DETERMINATION OF NON-SIGNIFICANCE

City of Bellevue
Development Services Department
Land Use Division Staff Report

Proposal Name:	AT&T Mobility LTE-SB 1636
Proposal Address:	1200 164th Avenue SE
Proposal Description:	Request for ACU approval to modify an existing Wireless Communications Facility (WCF). Modifications include extending the existing utility pole by 8-feet and adding 3 panel antennas. Additional ancillary equipment will be placed within the existing underground equipment vault.
File Number:	12-108579-LA, Administrative Conditional Use
Planner:	Sally Nichols, Associate Planner
Applicant:	AT&T Christine Contreras, Ryka Consulting
Decisions Included:	Administrative Conditional Use Approval (Process II, Land Use Code 20.30E)

Director's Decision: **Approval with Conditions**

Figure 1 – Proposal Site Plan

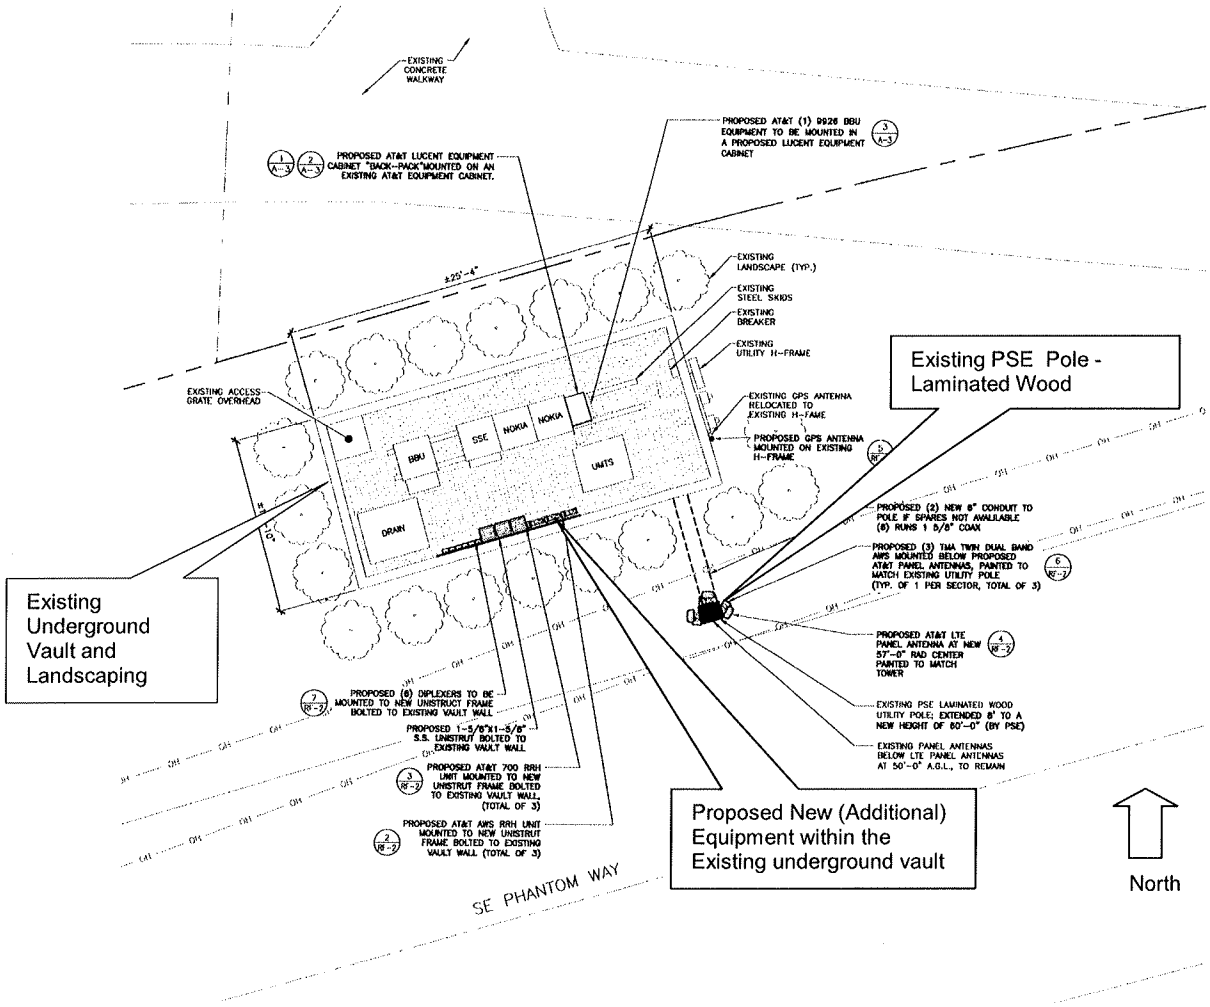
The applicant (AT&T Mobility) is requesting administrative conditional use approval to expand an existing wireless communications facility (WCF). The applicant is proposing to extend an existing 52-foot tall PSE pole (which currently supports three WCF antennas) by eight feet. Three new LTE panel antennas will be flush-mounted on this extension and painted to match the pole. Proposed new ancillary equipment, including one new equipment cabinet, will be placed in the existing underground vault and will be screened with the existing mature vegetation that was required per a condition of approval for the existing WCF. This WCF upgrade will allow the applicant to expand its high speed data networks to meet the needs of residents in the Sammamish/East Lake Hills neighborhood.

Figure 2
South Elevation – Looking North from SE Phantom Way

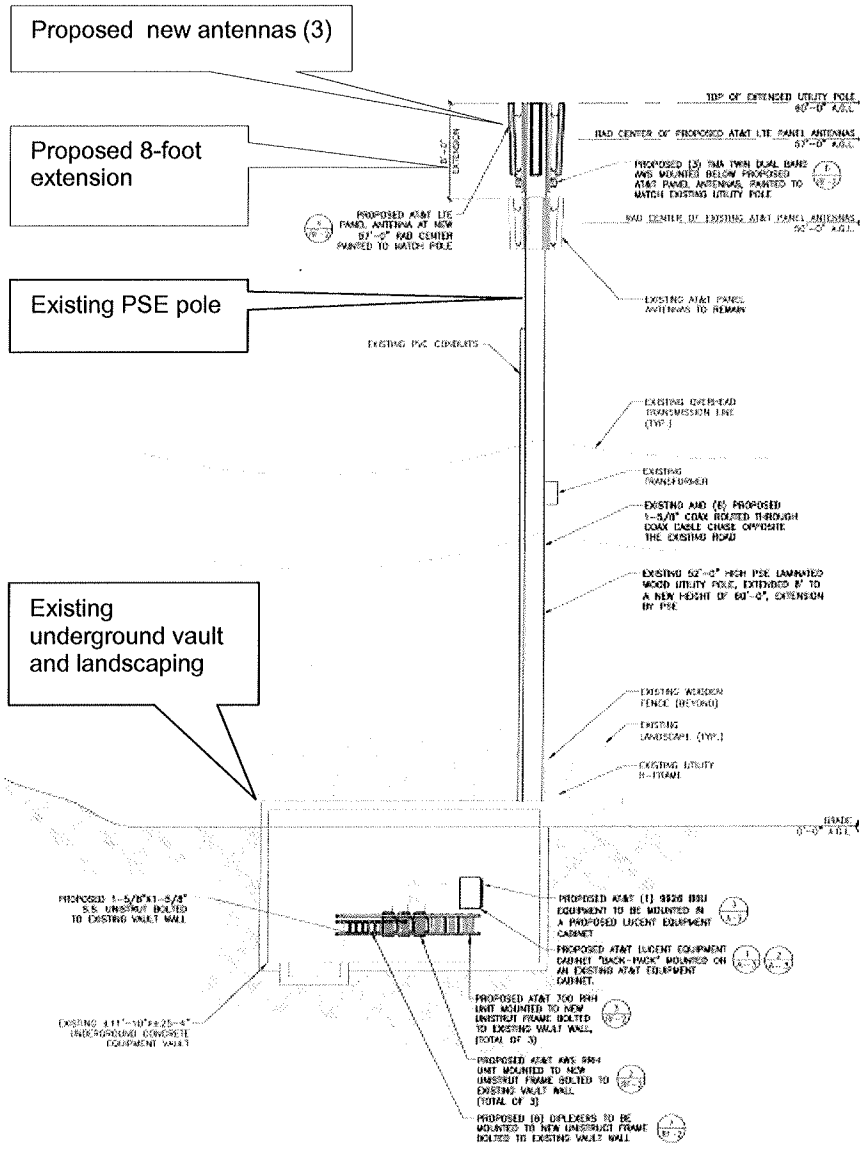
Finding: Significant improvements were previously made when the existing WCF was installed. The antennas were placed on a new wooden, glu-lam pole and they were painted to match the pole. The equipment vault was placed underground and landscaping around the vault effectively screened it from the public right of way and Lake Hill Community Park. Because there will be no exterior changes to the vault, no additional landscaping will be necessary. **Refer to Figure 2 in Section 4 of this report for photos of the existing condition.**

As conditioned, the pole extension will be of a similar material and color as the pole and the new antennas will be painted to match the existing utility pole and existing antennas. In addition, the existing three antennas will be required to be repainted so that all six antennas will have exactly the same color. **Refer to Condition of approval regarding antenna color/pole extension color and materials in Section VII of this report.**

Figure 4 – Site Photos

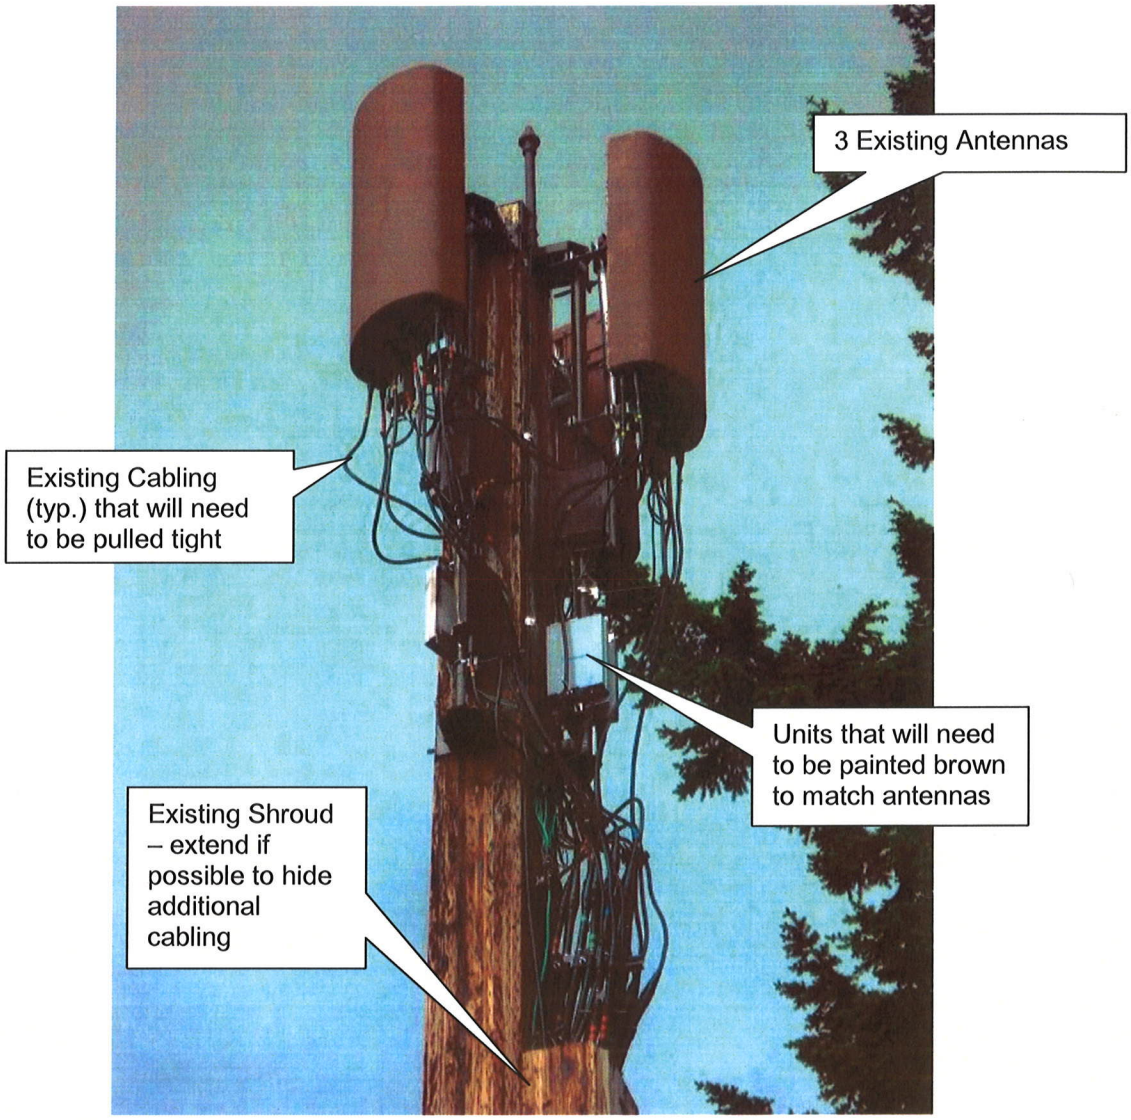
In addition, there are existing conditions on the pole that will need to be addressed along with the addition of the three new antennas. The existing cabling, as well as any new cabling, will need to be pulled tight and the shroud extended to hide as much as the cabling as possible. All antennas and equipment on the pole, either existing or proposed, will need to be painted brown to match the pole. As shown above, there are some units that are still silver in color and they stand out. **Refer to Condition of Approval regarding antenna and equipment color and pole extension color and material and cabling/shroud in Section VII of this report.**

Figure 6 – Search Ring (before and after)

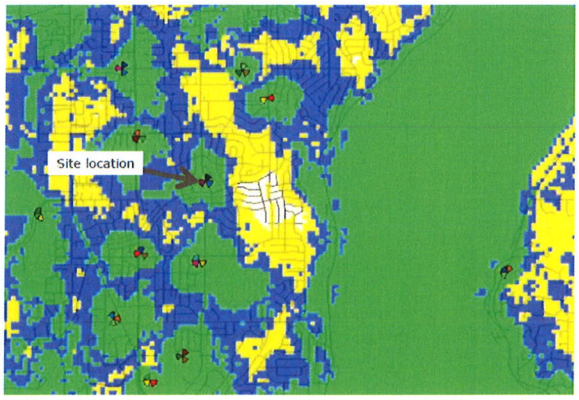
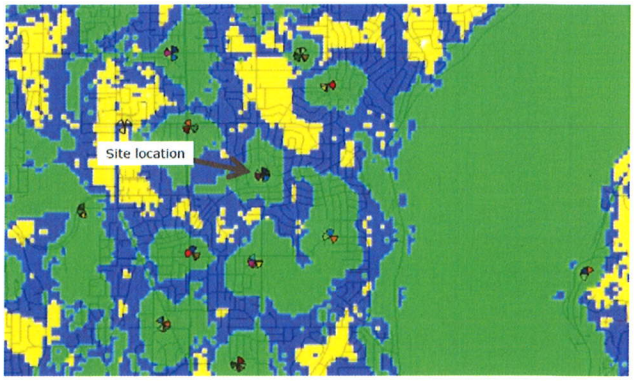
Finding: The entire coverage area as shown in the submitted search ring for this project consists of residential properties that are important to AT&T's coverage objectives. Thus, the location needs to be within this single family zoning district and no alternative, non-residential locations would have meet AT&T's functional needs.

a. **Preferred Location (LUC 20.20.195D.2.a):**
   Located within a single family residential land use district, the proposal falls within the least preferred location according to the siting criteria of LUC 20.20.195.D.2.a. However, while non-residential property would be a preferred location, no such option exists given the coverage area requirements for this application; the coverage area search ring is entirely within an area consisting entirely of park sites and residential land use districts. **Refer to the Figure 6 – Search Ring in Section V of this report.**
